## AMENDMENTS TO THE DRAWINGS

Appln. No. 09/552,590  
Amend. Dated: 3/18/04  
Reply to Office Action of 12/19/03  
Replacement Sheet

**FIG. 12**

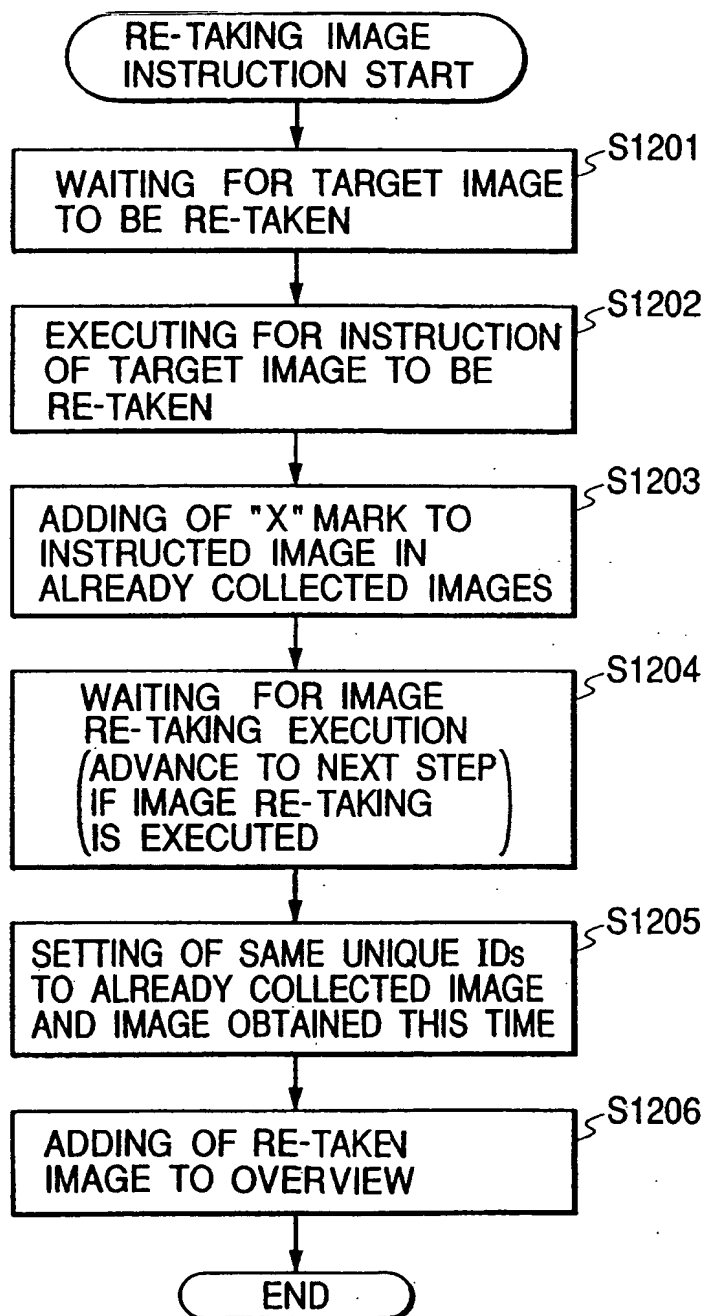
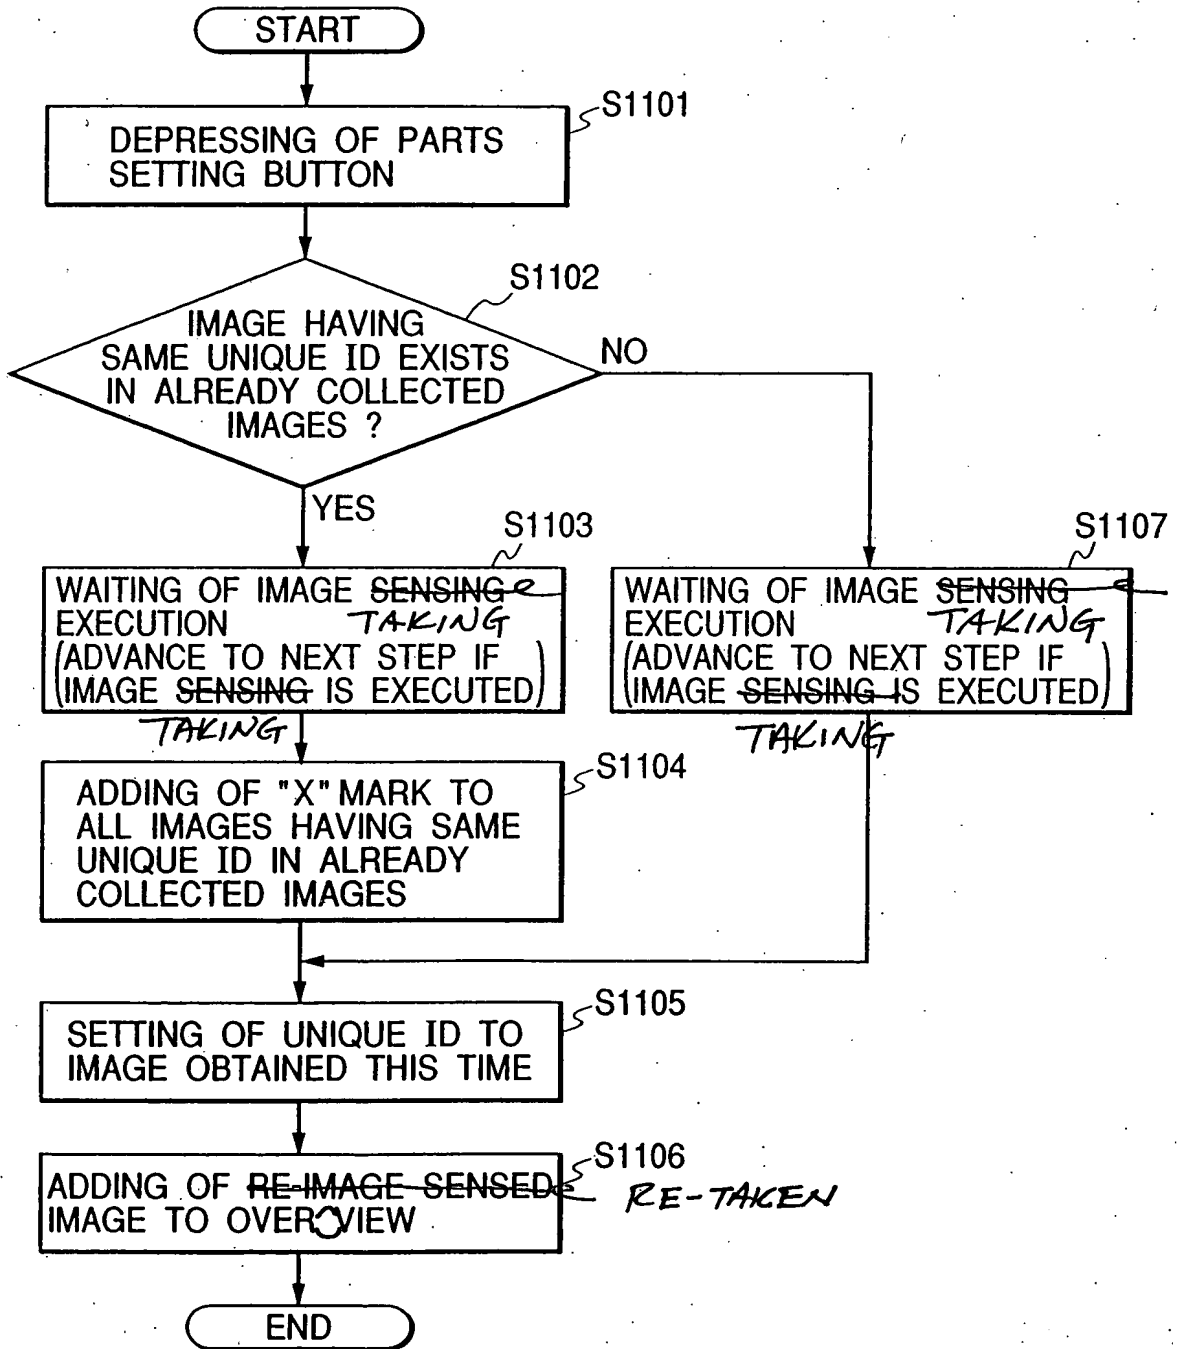
Fig. 12, change "RE-IMAGE SENSING INSTRUCTION START" to --RE-TAKING IMAGE INSTRUCTION START--, change "WAITING OF TARGET IMAGE TO BE RE-IMAGED SENSED" to --WAITING FOR TARGET IMAGE TO BE RE-TAKEN--, change "EXECUTING OF INSTRUCTION OF TARGET IMAGE TO BE RE-IMAGED SENSED" to --EXECUTING FOR INSTRUCTION OF TARGET IMAGE TO BE RE-TAKEN--, change "WAITING OF RE-IMAGE SENSING EXECUTION (ADVANCE TO NEXT STEP IF RE-IMAGE SENSING IS EXECUTED)" to --WAITING FOR IMAGE RE-TAKING EXECUTION (ADVANCE TO NEXT STEP IF IMAGE RE-TAKING IS EXECUTED)--, and change "ADDING OF RE-IMAGE SENSED IMAGE TO OVER VIEW" to --ADDING OF RE-TAKEN IMAGE TO OVERVIEW--.

FIG. 13

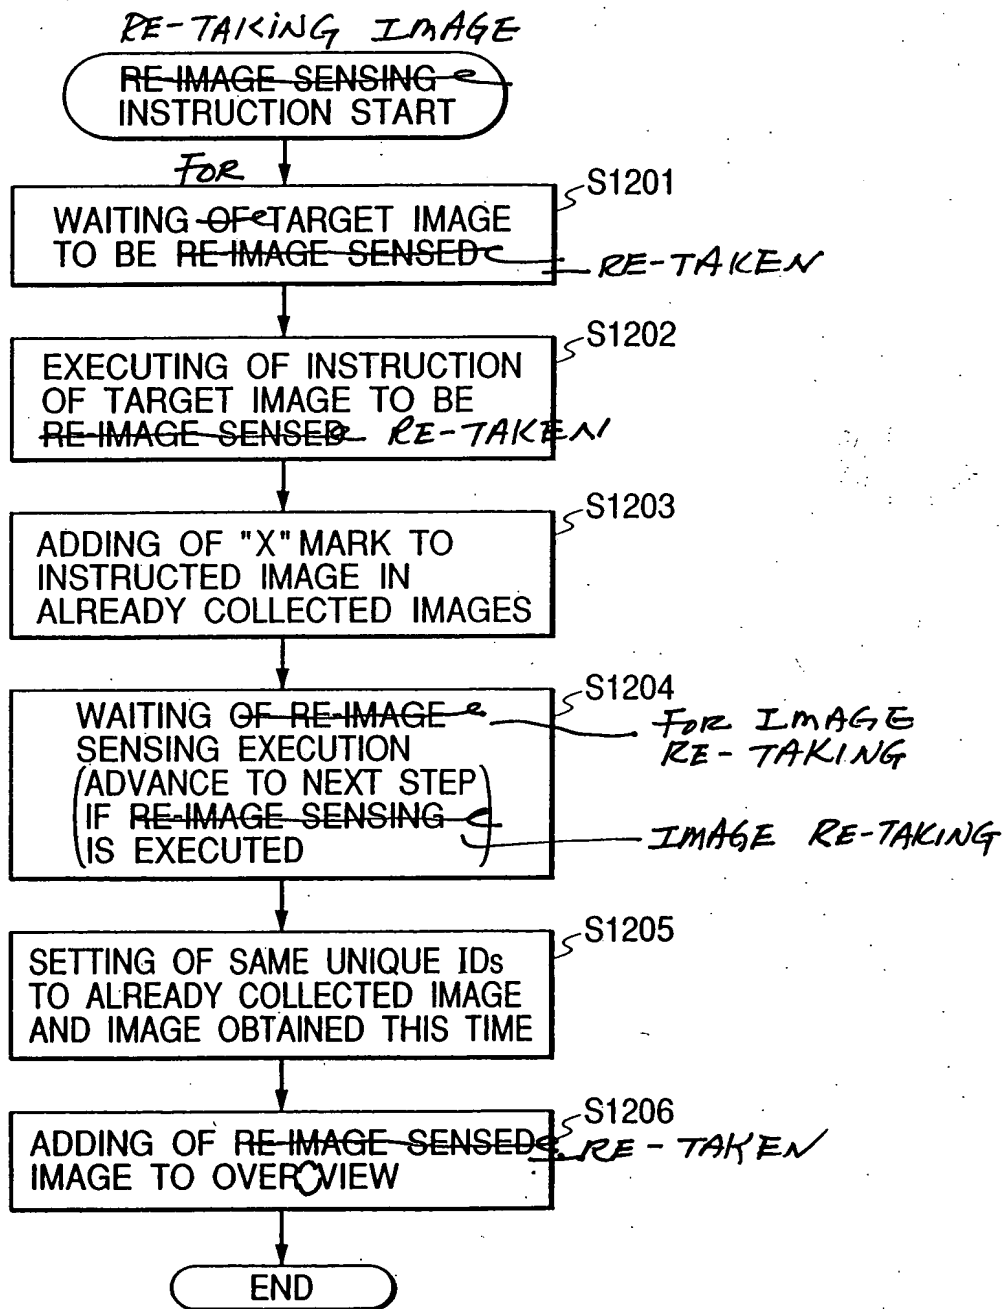
Fig. 13, change all occurrences of "OVER VIEW" to --OVERVIEW--.
